Access Compliance Report

Public Rights-of-Way

(Curb Ramps)

Intersection ID: 21064	Main Street: BASS_LN	Cross Street: EDMORE_CT	Location: SW
ADA ID: F1153186D3C4	Ramp Type: PerpDiag	Initial Pass/Fail: Fail	Overall Compliance: No
		Severity Score: 12.5

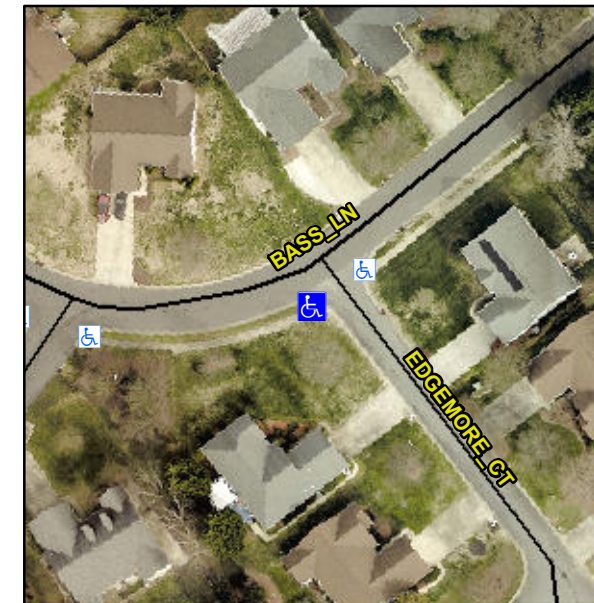
Not Found, R304.5.3

Compliance	Description	Data	Compliance	Description	Data
N/A	Ramp Length (in)	36.0	Yes	Ramp Slope (%)	5.3
Yes	Ramp Width (in)	48.0	No	Ramp XSlope (%)	5.2
N/A	Flare Type LT	N/A	N/A	Flare Type RT	N/A
N/A	Flare Slope LT (%)	N/A	N/A	Flare Slope RT (%)	N/A
N/A	Flare Traversable LT?	N/A	N/A	Flare Traversable RT?	N/A
N/A	Landing Length (in)	N/A	N/A	DWS Provided?	N/A
N/A	Landing Width (in)	N/A	N/A	DWS Contrast?	N/A
N/A	Landing Slope (%)	N/A	N/A	DWS Length (in)	N/A
N/A	Landing X Slope (%)	N/A	N/A	DWS Full Width?	N/A
N/A	Landing Curb? (Y/N)	N/A	N/A	DWS Offset (in)	N/A
N/A	Shared Landing?	N/A			
N/A	Gutter Ponding?	N/A	N/A	Gutter Slope (%)	N/A
N/A	Gutter Lip Ht (in)	N/A	N/A	Gutter X Slope (%)	N/A
N/A	Painted X Walk1?	No	N/A	Painted X Walk2?	No
	X Walk 1 Direction	To E		X Walk 2 Direction	To N
N/A	X Walk 1 Width (in)	N/A	N/A	X Walk 2 Width (in)	N/A
	X Walk 1 Slope (%)	0.9		X Walk 2 Slope (%)	1.7
	X Walk 1 X Slope (%)	1.3		X Walk 2 X Slope (%)	2.5

Remove & Replace Curb Ramp With Two New Directional Ramps or Equivalent.
